ORDER—dated 20th December 1887, No. 3484 W., Public Works.

Madras Harbour

Despatch from the Secretary of State communicating, with remarks, report of the special committee on the question of the entrance to the —, communicated to the officers concerned.

In compliance with the instructions contained in your letter of 8th April, we have examined thoroughly into the subject of the position of the entrance to Madras Harbour, in connection with the work of reconstruction now in progress.

rawing N^o 2.

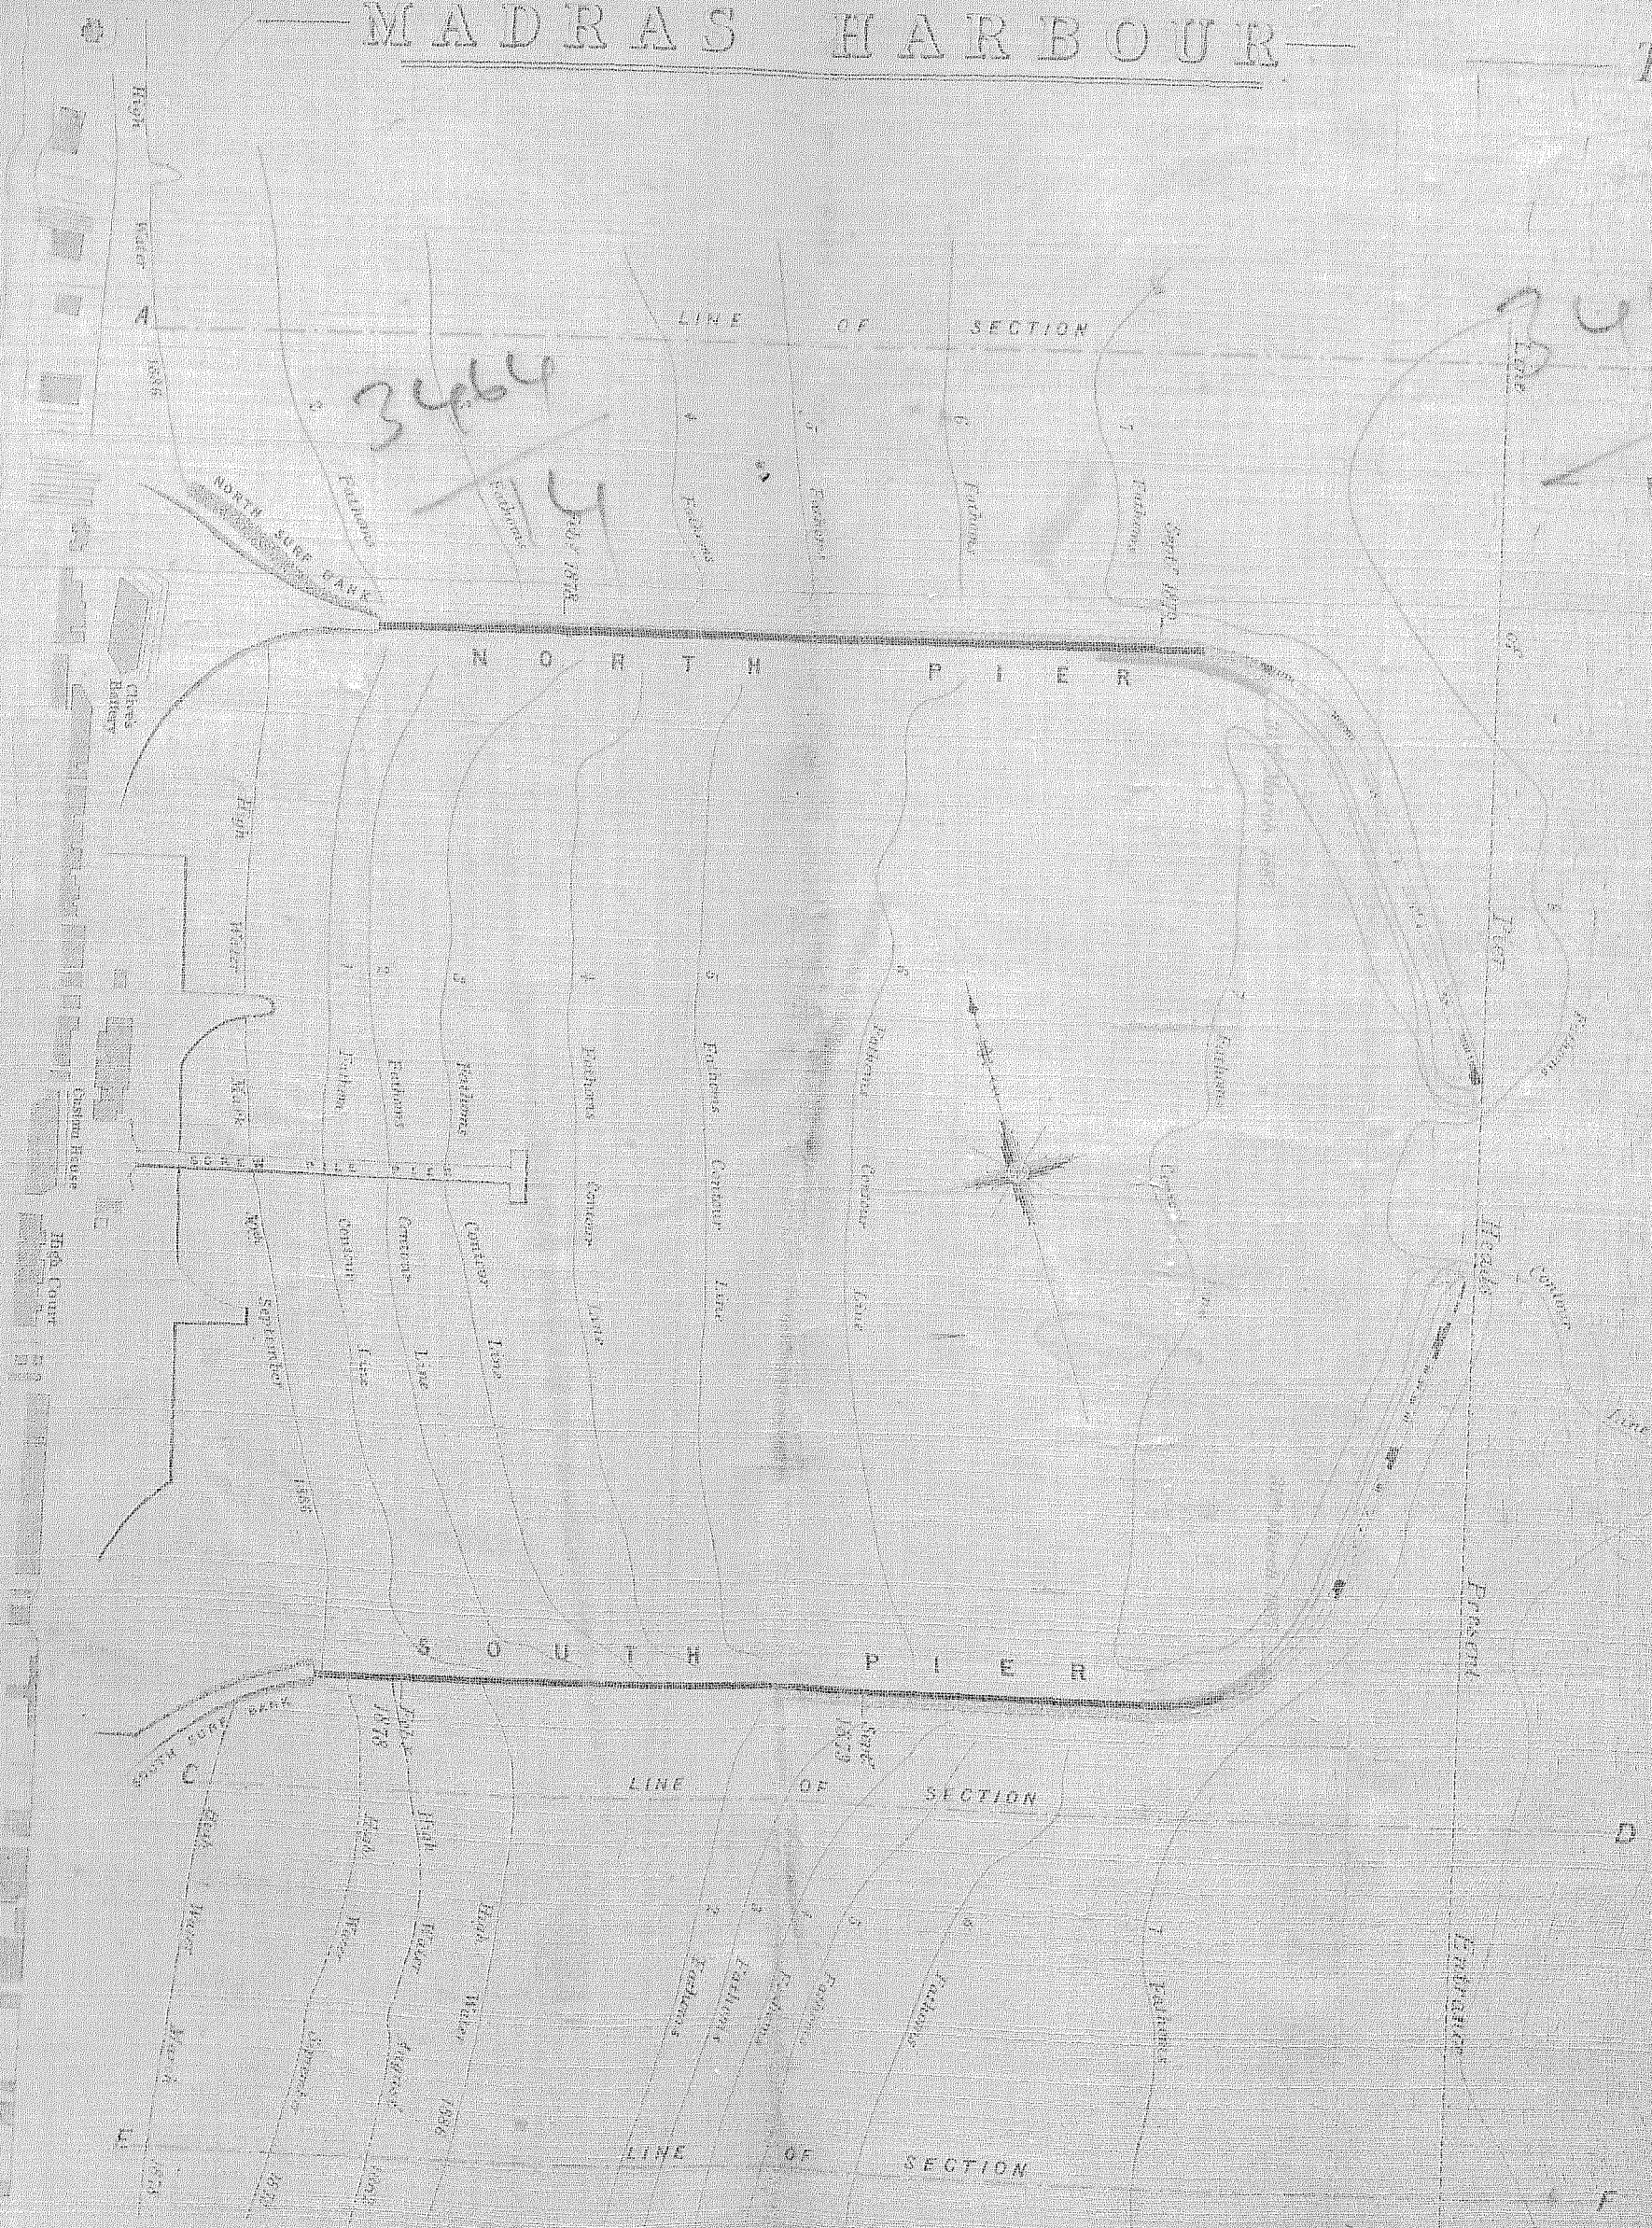
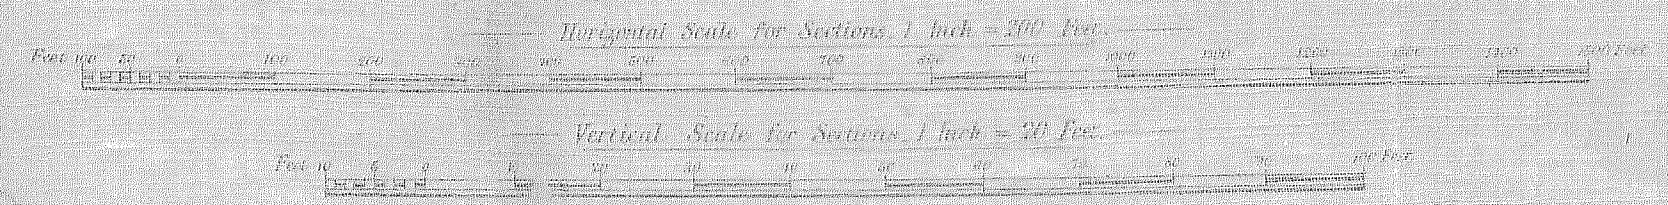
Drawing No. 2 contains a plan of the harbour in its present condition, and also three sections which we have had prepared in order to illustrate, as clearly as possible, the changes which have taken place in the depths immediately to the northward and southward of the harbour within the last few years.

The proposal to open the harbour at the south-east corner, whether alone or in conjunction with another opening at the north-east corner, we feel bound to dismiss. Our calculations, founded upon soundings taken and submitted to us by Mr. Parkes, more especially a comparison of those taken in 1886 with those taken in 1882, show that, so rapid and regular is the encroachment of the sand on the south side, that, if continued at the same rate, which we have strong reason to apprehend will be the case, within twenty years the depth of water at the south-east corner will be reduced to four fathoms.

Works recommended by Committee shown in red ink

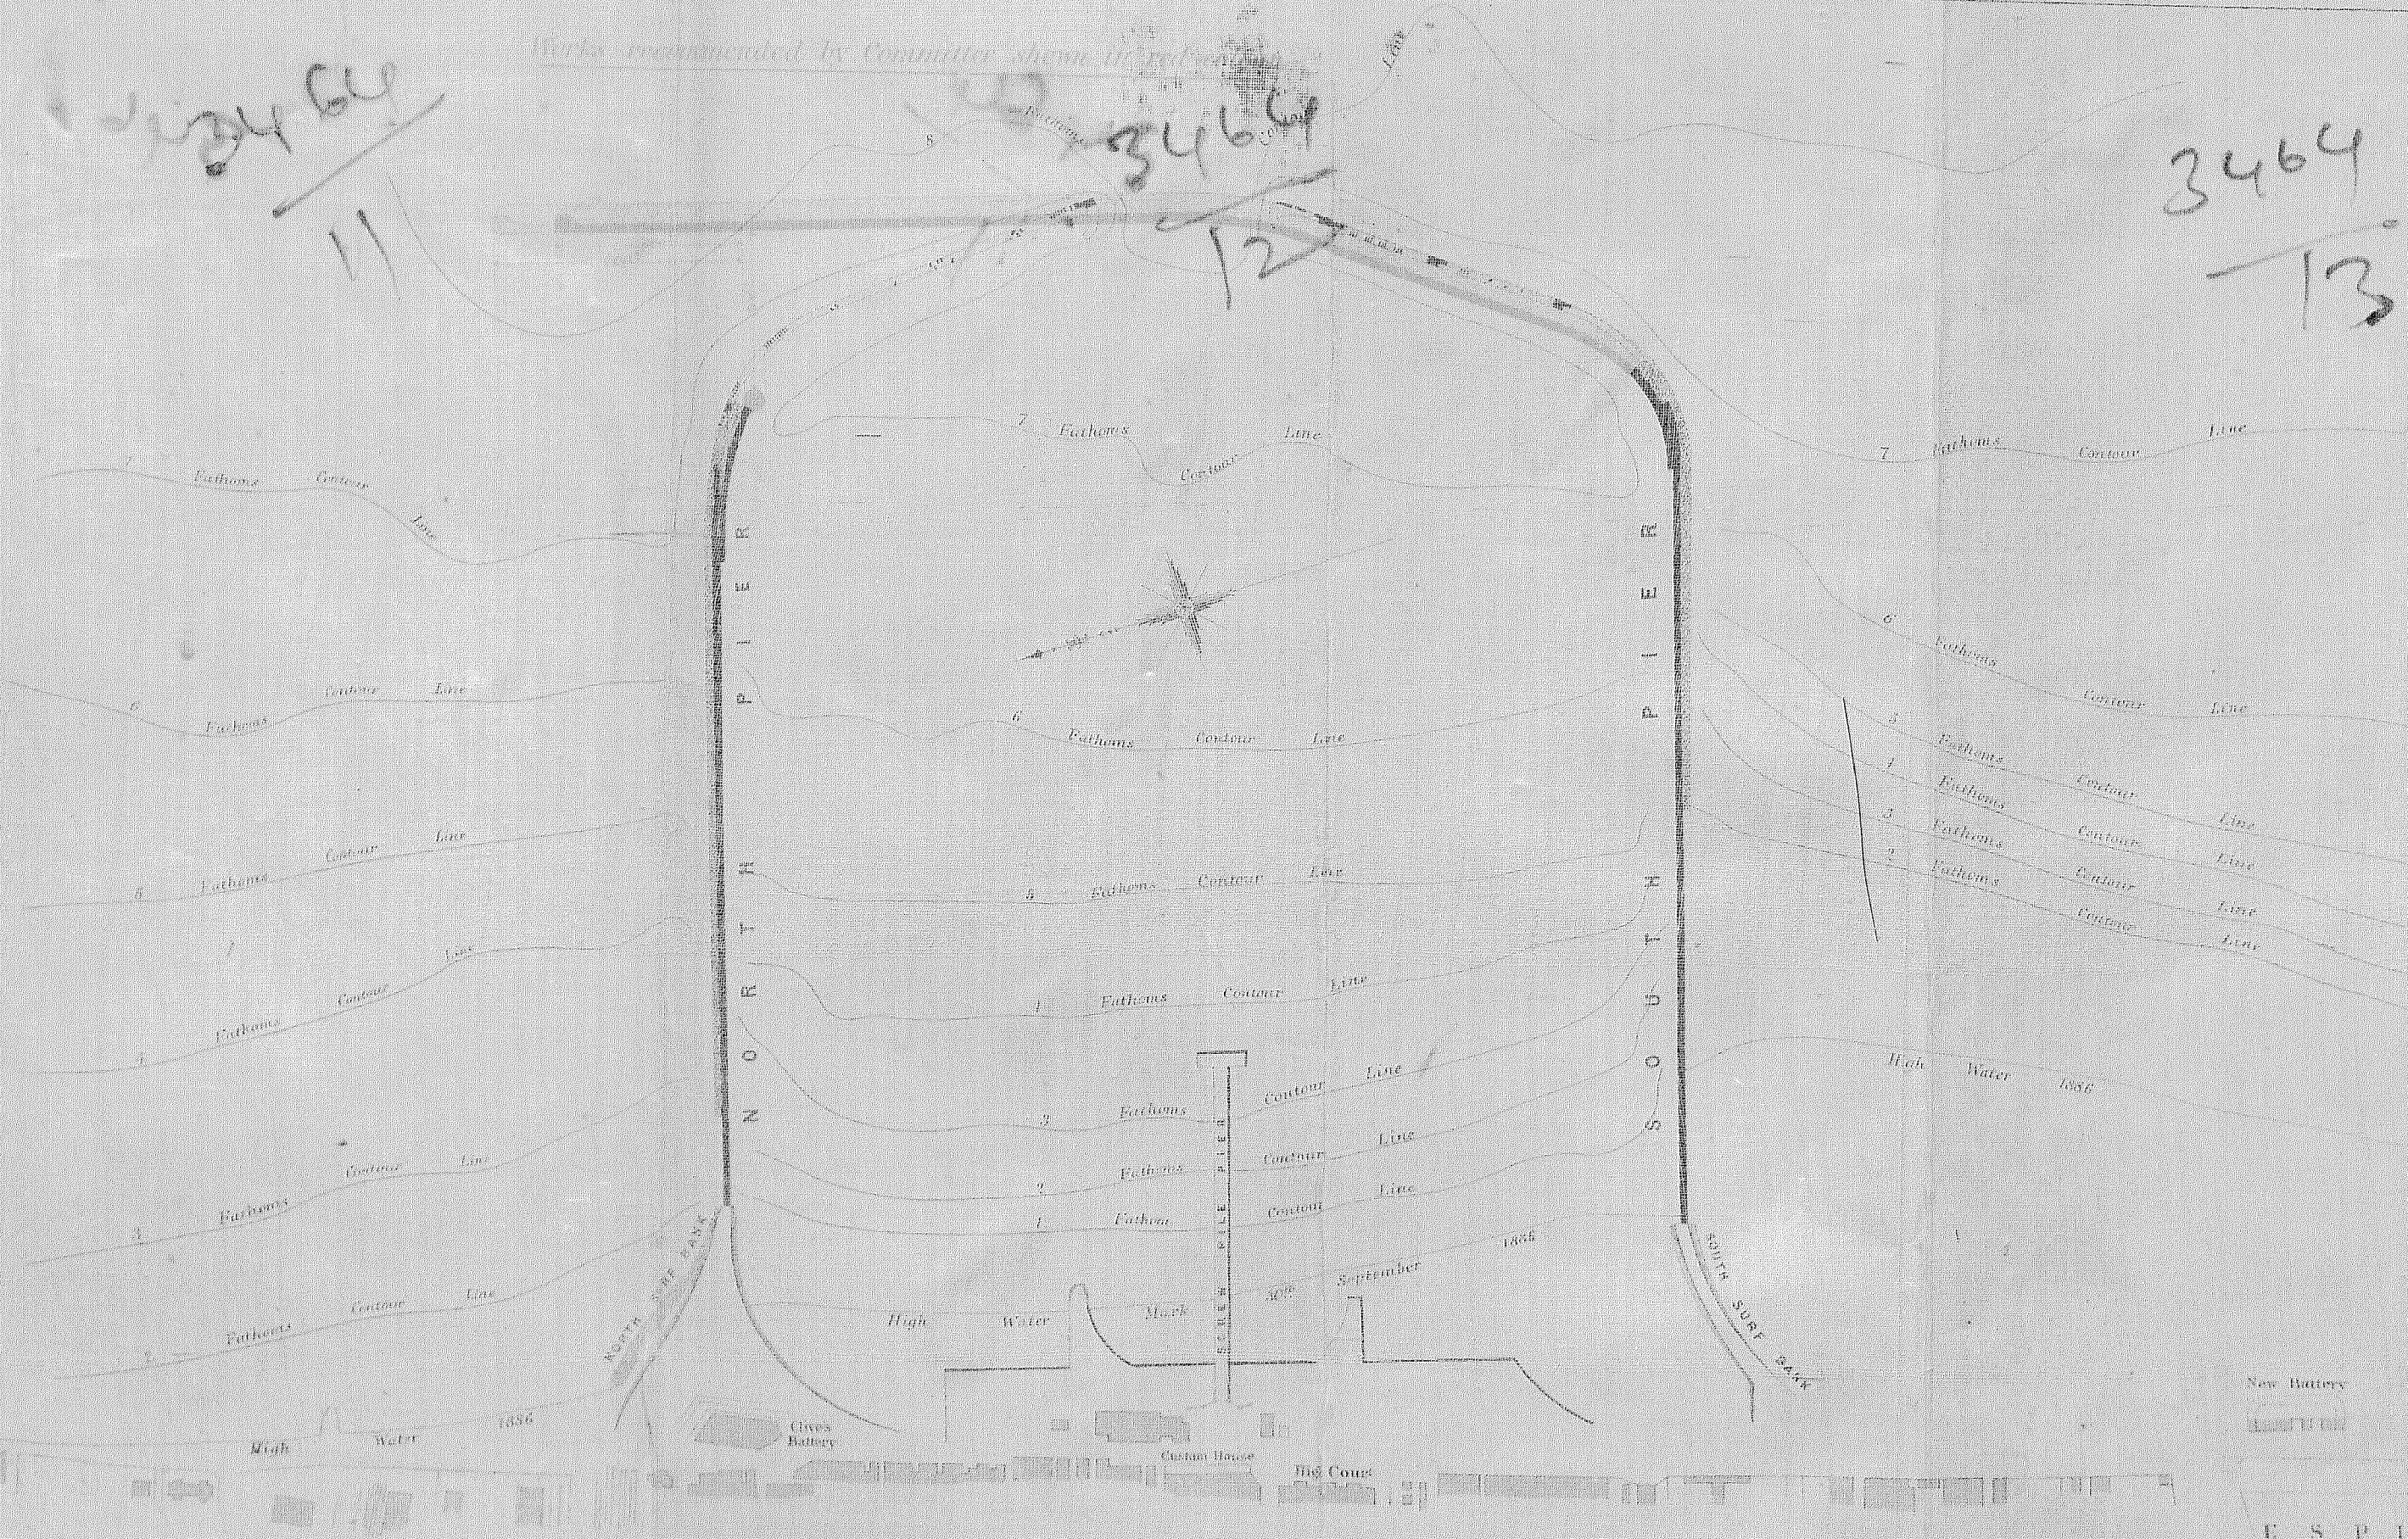
Drawing No. 3 shows, by red colour, the position, aspect, and covering arm of the new north-east entrance, which we have to recommend for adoption.

Having carefully weighed all the evidence we have been able to collect, which comprises the views of all classes interested, or who have had opportunities of forming an opinion, we pronounce in favour of an entrance at the north-east corner, with a covering arm, and that the entrance on the east face be closed up.

It appears, therefore, according to the estimates put before us by Mr. Parkes, that the expenditure to be incurred as from 31st March last, in executing the work according to our recommendation (shown in red colour on Drawing No. III. annexed to this Report) will amount to about 47½ lakhs of rupees with an overlap of 600 feet, and to about 50 lakhs of rupees if it should be found necessary to make the overlap 800 feet.

In this estimate it is assumed, that the *débris* of the old work will be removed to a depth of 36 feet below low water of lowest tides throughout the new entrance, which depth we regard as a minimum, and we are distinctly of opinion that not less than this should be sanctioned.
